Midland Knitwear Ltd. (Extension)

Stadium Link Road, Narayanganj 1421

20 December 2023

2. Observations

Observation-1: Considered loading doesn't comply with BNBC 2006. (Extension building-02)

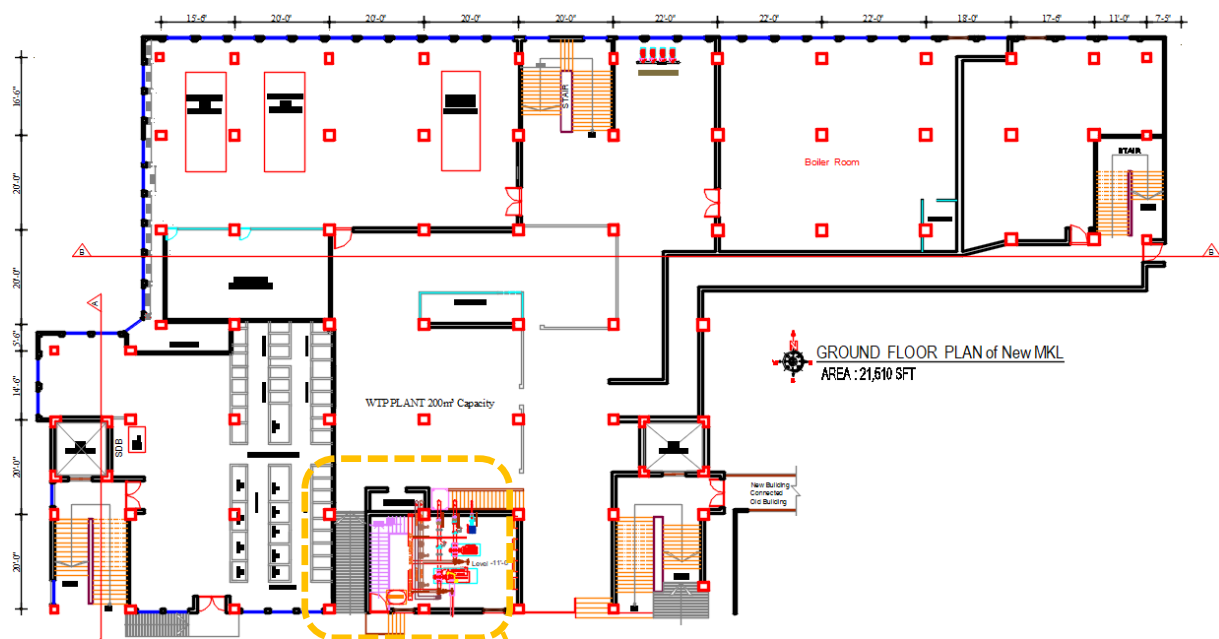
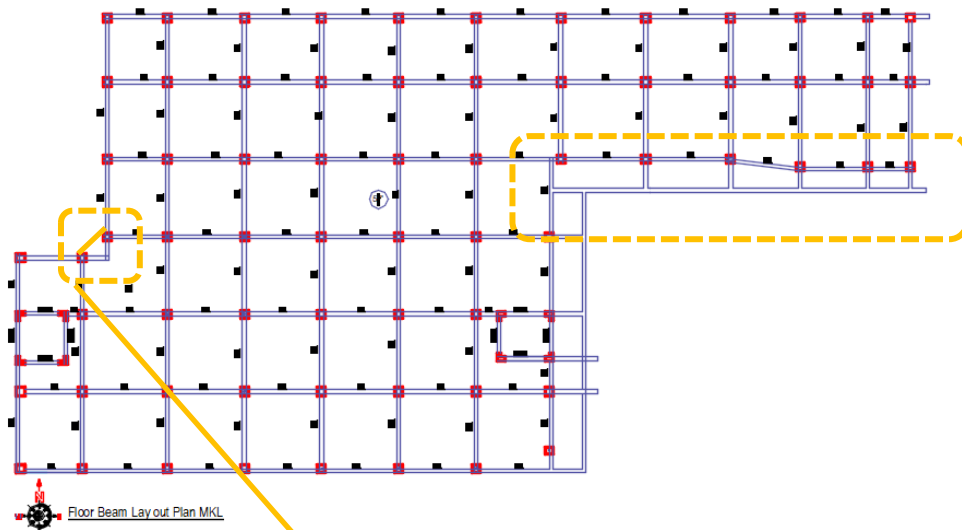
Description: During the inspection, live load for storage area in several locations was found considered 4 kPa which doesn't comply with BNBC 2006. Also, in stairs, the live load was considered 4 kPa instead of 5 kPa. Furthermore, the load of large vessels over the ground floor suspended slab was not incorporated in the analysis model.

The building engineer is required to survey the whole structure revise the design documents as per BNBC loading and submit it to RSC for review.

Observation-3: Stress in column exceeds normal design limit (Admin Building).

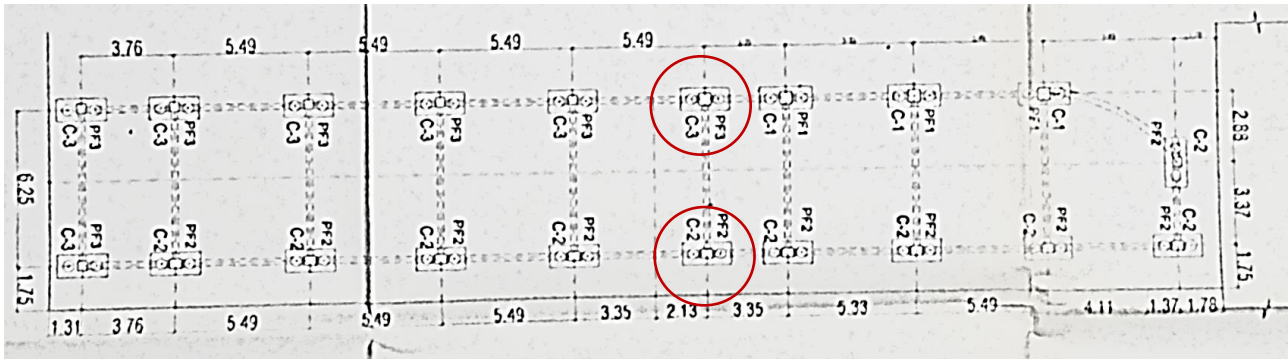
Description: The cursory calculation indicates that column stress exceeds the normal design limit considering a typical floor live load of 2kPa, roof live load of 1.5 kPa, and concrete strength of 16.31 MPa.

The building engineer is required to review the design, loads, and column stresses for the marked columns based on in-situ material strength.

Observation-5: Discrepancies in as-built drawings (Admin Building).

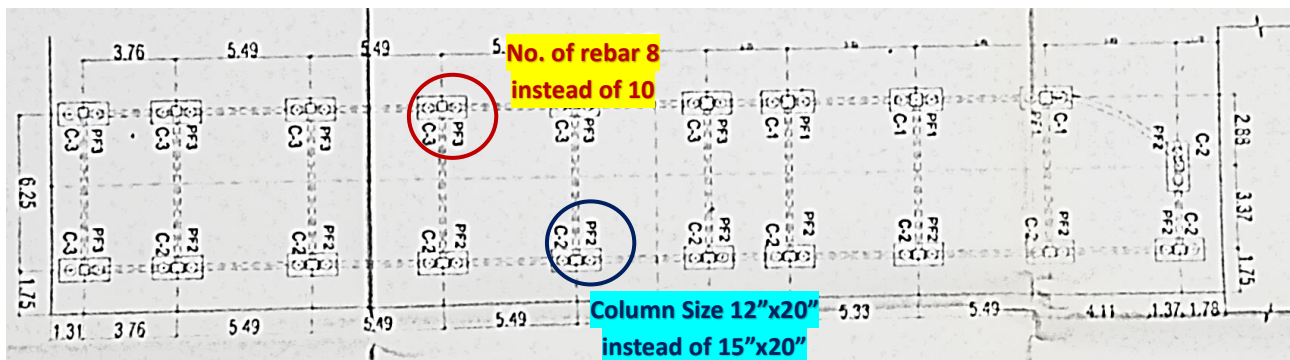
Description: During the inspection, mismatches were found between the onsite condition and the as-built drawing. Discrepancies were found in column size (C-2), and column rebar (C-3). Also, the beam layout was missing in the as-built drawings.

The building engineer is required to survey the full structure and produce accurate as-built drawings.

Observation-6: Load transfer from the connection bridge (Admin Building).

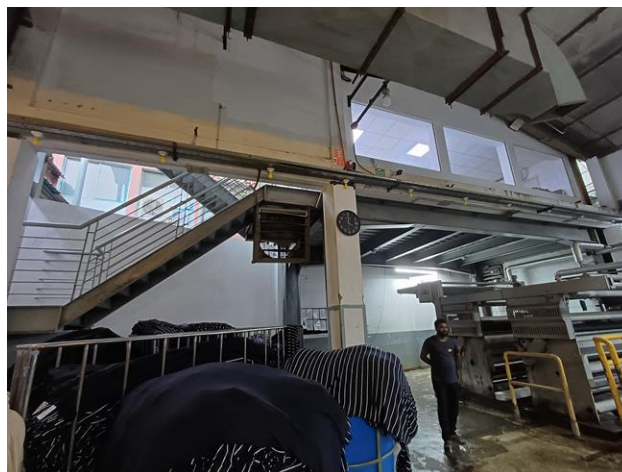
Description: During the inspection, a connecting bridge was observed between the admin building and Liberty Knitwear Ltd (ID-9501) at the 2nd-floor and 3rd-floor levels.

The building engineer is required to survey the full structure and produce accurate as-built drawings. Also building engineer is required to check the load transfer mechanism from the connecting bridge and include in design report. Factory is required to submit the required design documents to RSC for review.

Observation-8: Incomplete as-built drawings (Dyeing and Finishing (Office Building))

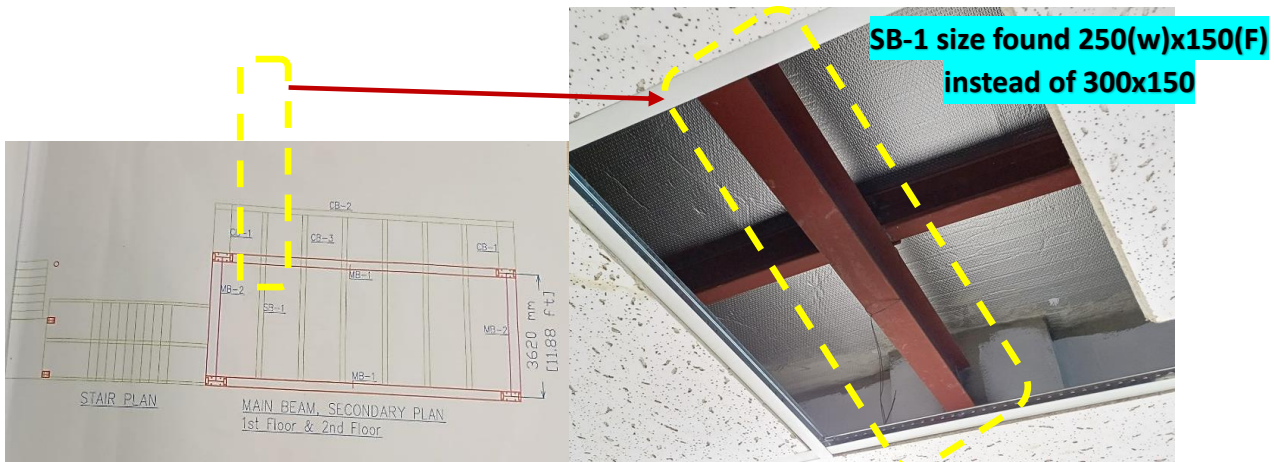
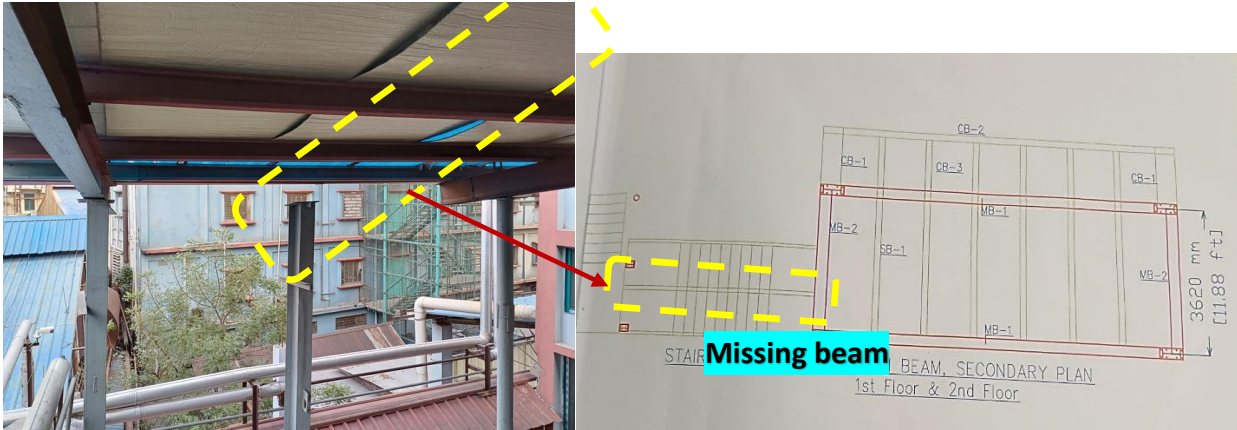
Description: During the inspection, the Roof beam was found missing. Also, the SB-1 beam size was found changed. Furthermore, no connection details and dimensions were provided. The building engineer is required to survey the full structure and produce accurate as built drawings

Observation-9: Crack found in column (Dyeing & Finishing Shed-1).

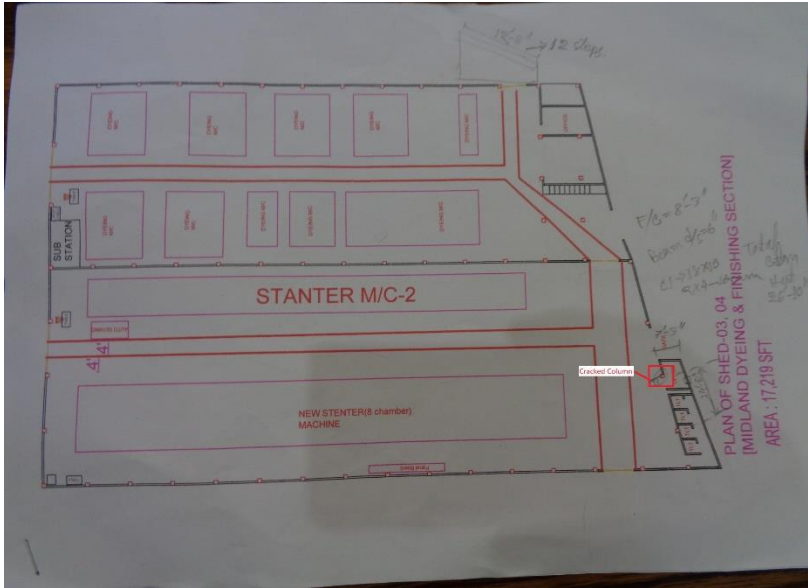
Description: Crack was found in the ground floor column of the two-storied RC mezzanine of the Dyeing & Finishing Shed-1 marked in the provided layout. The factory must immediately engage a consultant to investigate the cracks and prepare a detailed investigation report with proper remediation methodology. Any safety measures, if required as suggested by the consultant, must be taken immediately to ensure safety.

Observation-10: Inconsistencies in as-built drawings and lack of design documents.
(Dyeing & Finishing Shed-1).

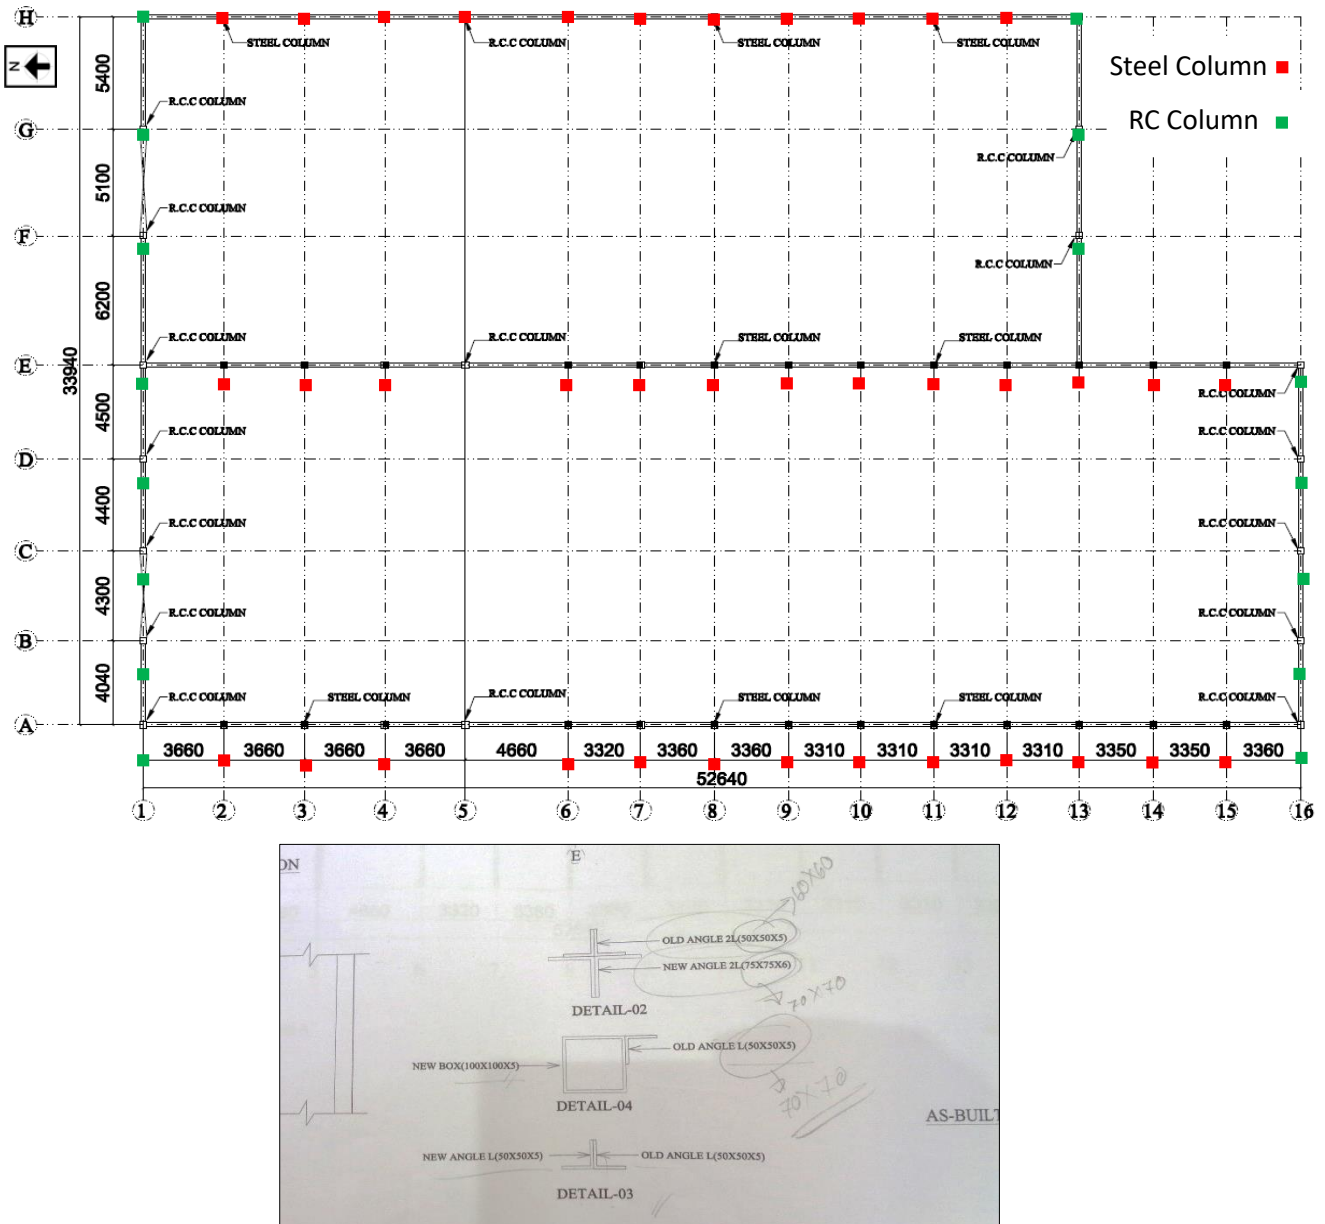
Description: During the inspection, mismatch was found between the provided as-built drawing and the actual site condition. Steel columns were found in the red-marked location which has not been shown in the drawing. The bottom cord angle leg length was found to be 60mm and 70mm instead of 50mm and 75mm respectively. The angle leg length of the top cord was found 70mm instead of 50mm. The Truss layout has not been shown properly in the drawing. No information has been provided for the RC Mezzanine.

As per BNBC, every building or structure designed shall have its design documents prepared following the provision of Section 1.9.1. During the inspection, the design report and as-built structural drawing were not available on site. The building engineer is required to survey the whole structure and prepare accurate as building as-built drawings. Also Building engineer is required to prepare a set of design documents including as-built drawings, live load plan at the roof and a design report based on actual site condition in compliance with section 1.9.1, part-6 of BNBC.

Observation-11: Crack found in column (Dyeing & Finishing Shed-2: Part A-Finishing Shed).

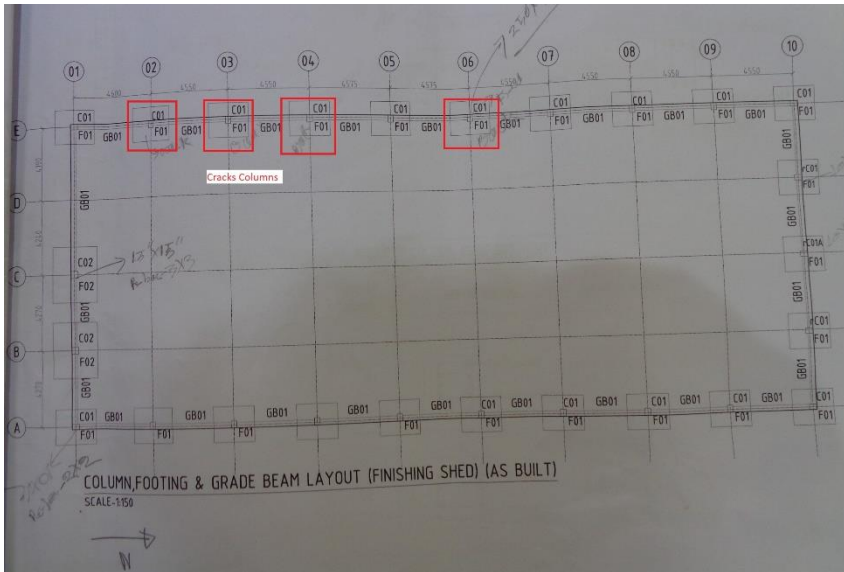
Description: Crack was found in the ground floor column of Dyeing & Finishing Shed 2 marked in provided layout. The factory must immediately engage a consultant to investigate the cracks and prepare a detailed investigation report with proper remediation methodology. Any safety measures, if required as suggested by the consultant, must be taken immediately to ensure safety.

Observation-12: Inconsistencies in as-built drawings and lack of design documents.
(Dyeing & Finishing Shed-2).

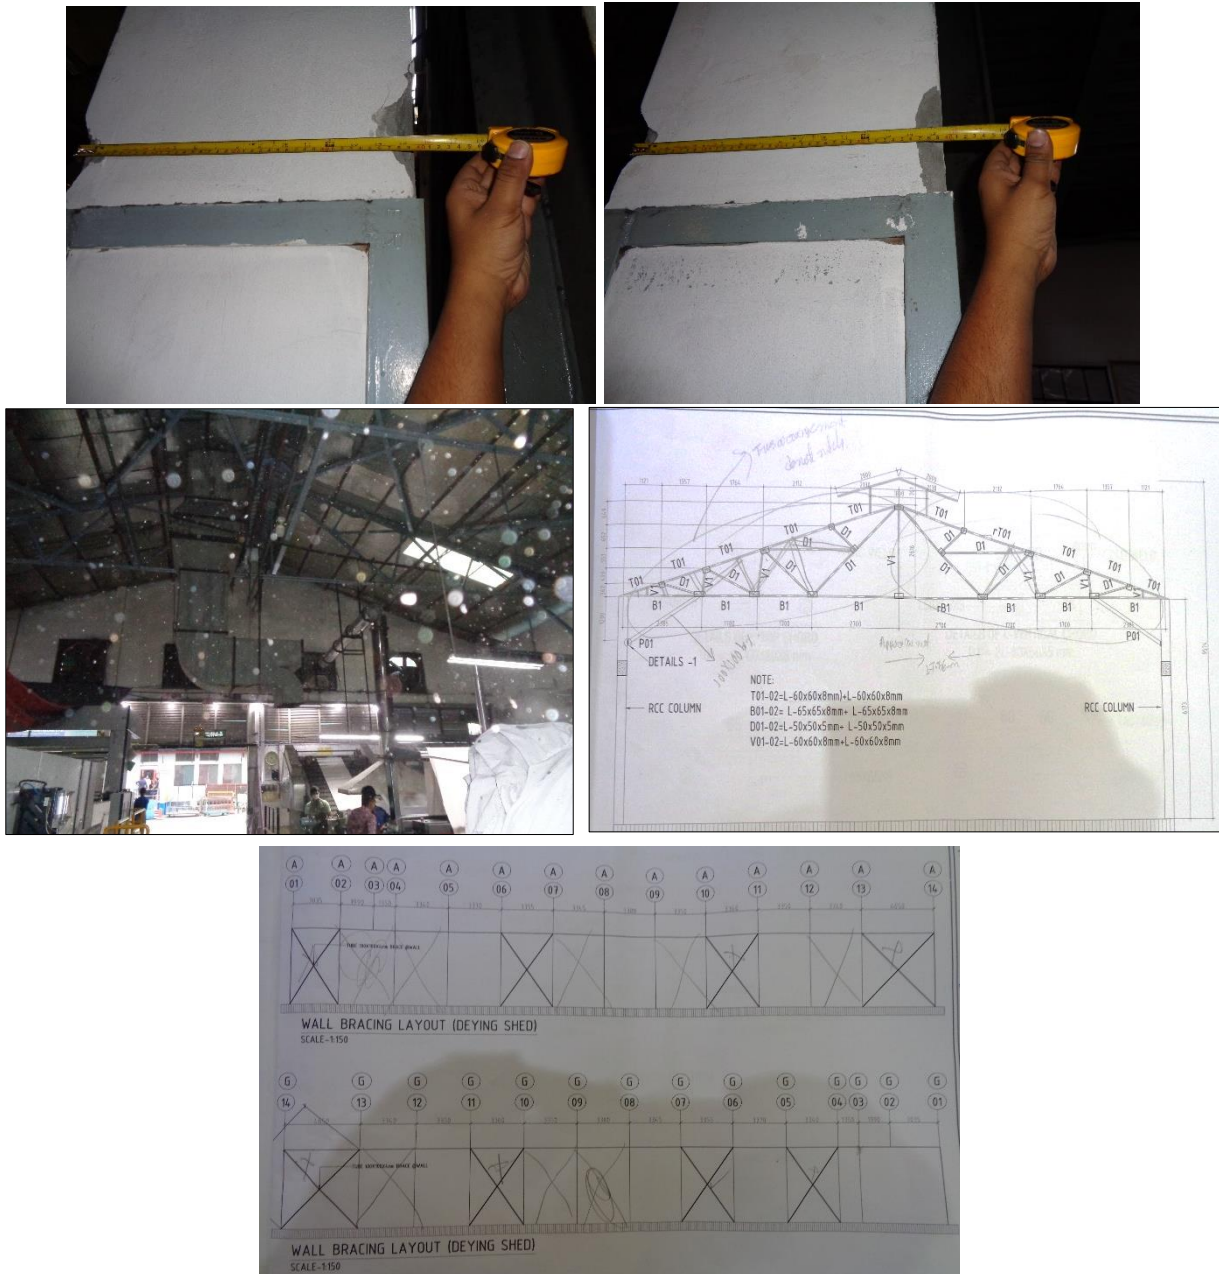
Description: During the inspection, mismatch was found between the provided as-built drawing and the actual site condition. The size of the RC columns do not match the as-built drawing. The arrangement of the vertical and diagonal members of the truss do not match the site condition. The truss was found at the gable but shown in the as-built drawing. The layout of the vertical bracing does not match with site conditions.

As per BNBC, every building or structure designed shall have its design documents prepared following the provision of Section 1.9.1. During the inspection, the design report and as-built structural drawing were not available on site.

The building engineer is required to survey the whole structure and prepare accurate as building as-built drawings. Also Building engineer is required to prepare a set of design documents including as-built drawings, live load plan at the roof and a design report based on actual site condition in compliance with section 1.9.1, part-6 of BNBC.
